6.1 AUDIT TEAM STATEMENT

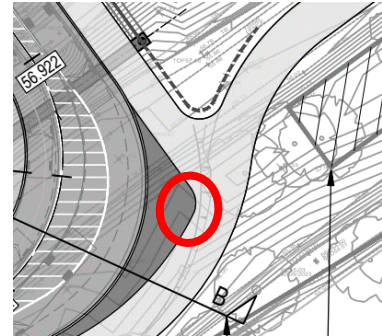
4.1.4 Problem (PC4) – Sharp Bend

There is a tight radius proposed along the shared facility in the vicinity of the off-road Greenway tie-in. This tight bend reduces comfort levels for cyclists and may result in loss on momentum or control.

Should this be deemed the priority route at this location, it is recommended that this radii be increased in-line with Section 4.1.4 of the current Cycle Design Manual.

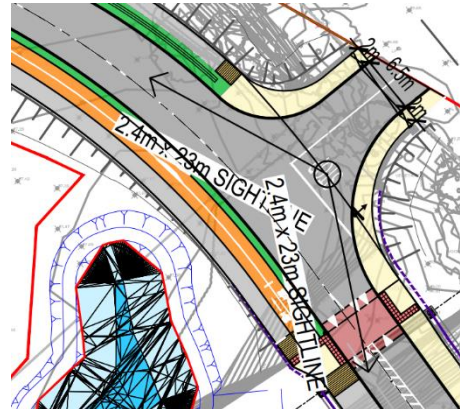
4.2.2 Problem (MV2) – Tactile Paving at Civic Office Access

There are no pedestrian crossing facilities provided on the pedestrian crossing desire line at the Civic Office access junction. As a result, visually impaired pedestrians may not be aware of the presence of a vehicular access and enter into the road carriageway when it is unsafe to do so, leading to conflict with vehicles.

Appropriately placed crossing facilities should be provided, with dropped kerbs (if necessary) & tactile paving, to cater for the pedestrian crossing.
